Date: April 14, 2022  
Refer To: N3B-2022-0146

**Subject: Resubmittal of Regional Aquifer Well R-73 WR-07 Permit Application and  
submittal of Regional Aquifer Well R-73 WD-09 Artesian Well Plan of Operations**

**Response to the State of New Mexico Office of the State Engineer Letter,  
“Regional Aquifer Well R-73 Monitoring Permit Application, OSE File No. RG-A030,”  
(Denial of Regional Aquifer Well R-73 Monitoring Permit Application),  
Dated April 6, 2022**

**Figure 1:** Plan View of Borehole and Casings (2.75-inch casters on the bottom)

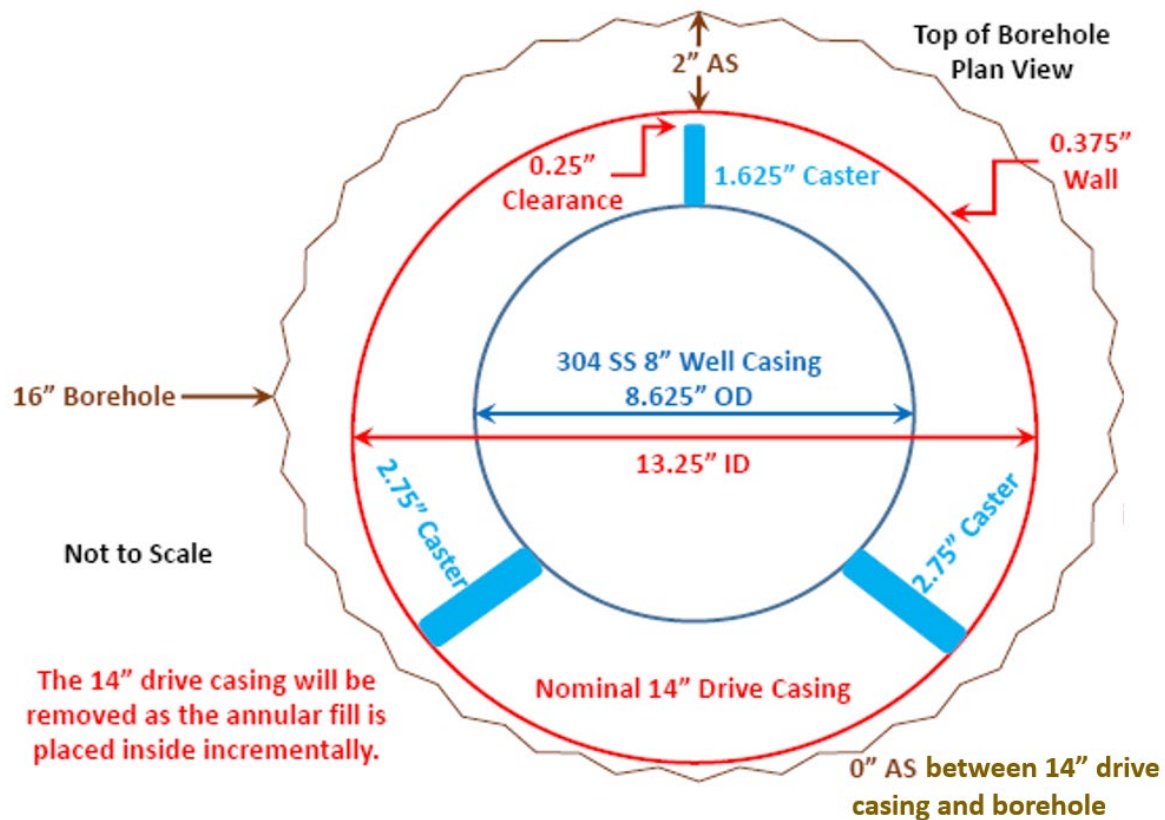
1. *As the annular dimensions change in relation to the size of the open-borehole and the “centralizers” being placed at 120 degrees from each other, it will need to be demonstrated how casing will maintain the minimum distance in the variance request.*

1. DOE is not requesting a variance and has provided information in Attachment A demonstrating how the minimal annular space requirement will be met. Following the calculations provided by the NMOSE, DOE has increased the size of the caster assembly to create a minimum of 2 in. between the well casing and the 14-in. and 16-in. drive casings. In addition, Attachment A provides a description of the well construction process demonstrating that the casters are designed to center the well casing in the drive casing during construction of the well, while the annular fill materials support the well casing as the drive casing is removed.

**Figure 1** shows a cross section of the borehole, drive casing, and well casing assuming that the 14-inch drive casing and casters center the well casing. As shown in **Figure 1**, this annular space is ~3.625 inches at the top well bore in the 16-inch borehole and ~3.125 inches at the bottom of the well bore. Using NMOSE's maximum deflection calculation for the casing, 0.066 inches, the casing maintains a minimum 3.059-inch distance from the borehole between the casters, well above the required 2 inches on the bottom side of the borehole.

R70.pdf

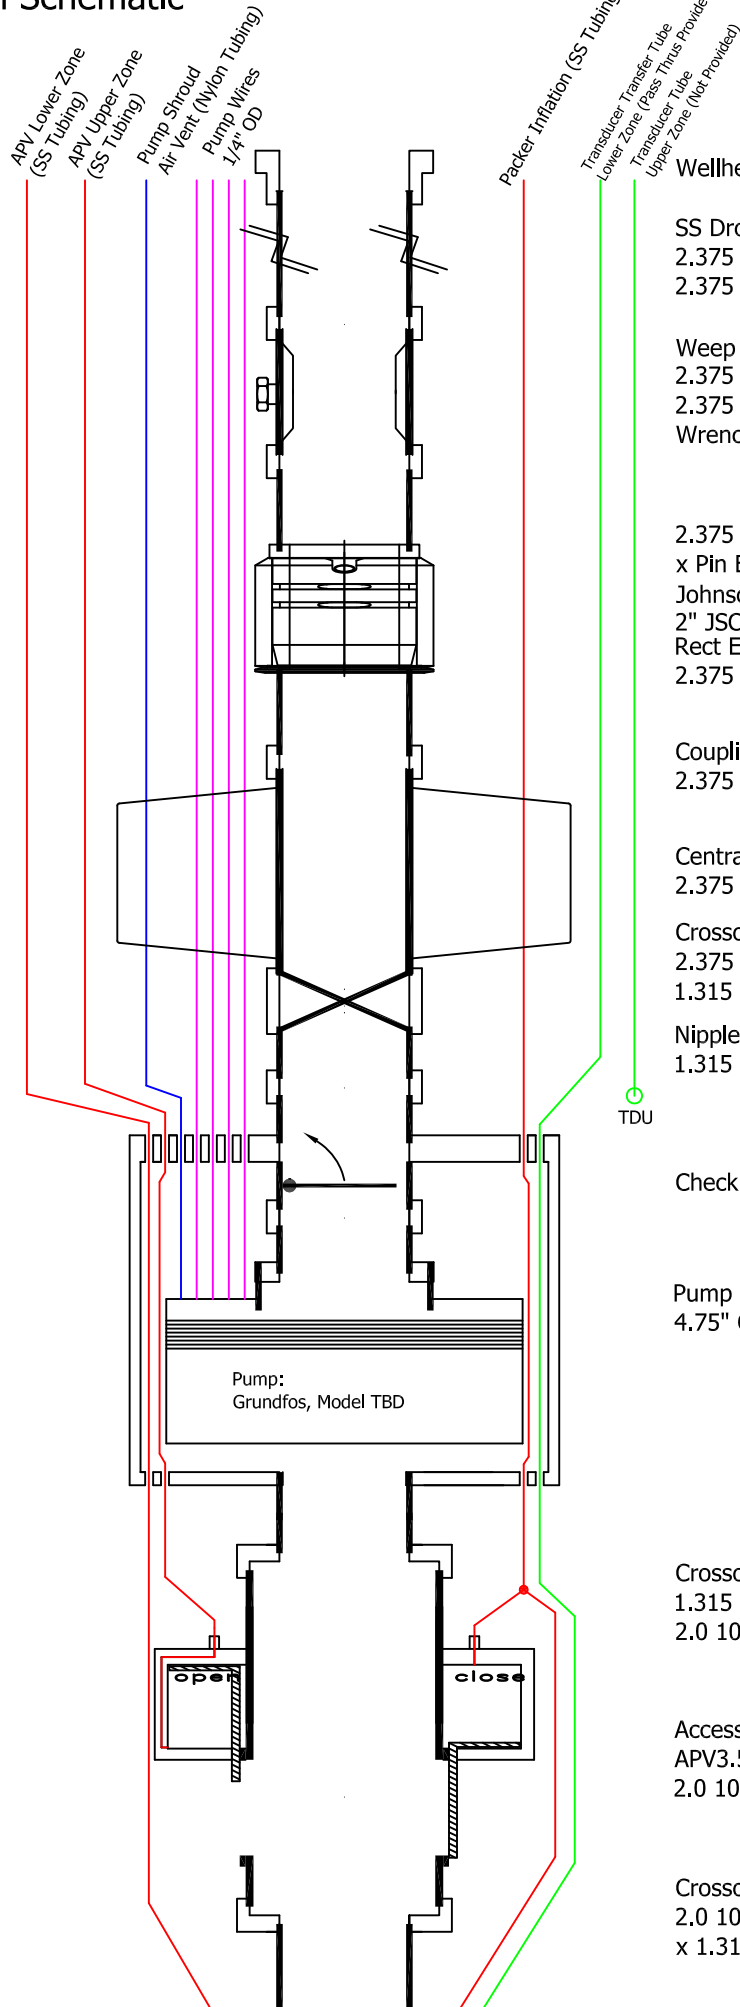
2. *Packer design specifications including but not limited to weight and seating pressure.*

2. DOE has provided the design specifications for the packer in Attachment B.

# Schedule 80 Male-X-Male Drop Pipe

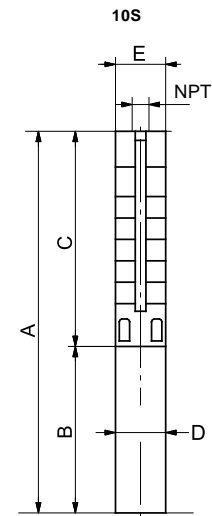
3. *Production tubing specifications including but not limited to type of materials, pounds per foot and tensional hanging forces.*

3. DOE has provided the tubing specification in Attachment C.

Information highlighted in yellow does apply as we normally use the 2" drop pipe as a standard for all monitoring wells of 8inch diameter well casing.
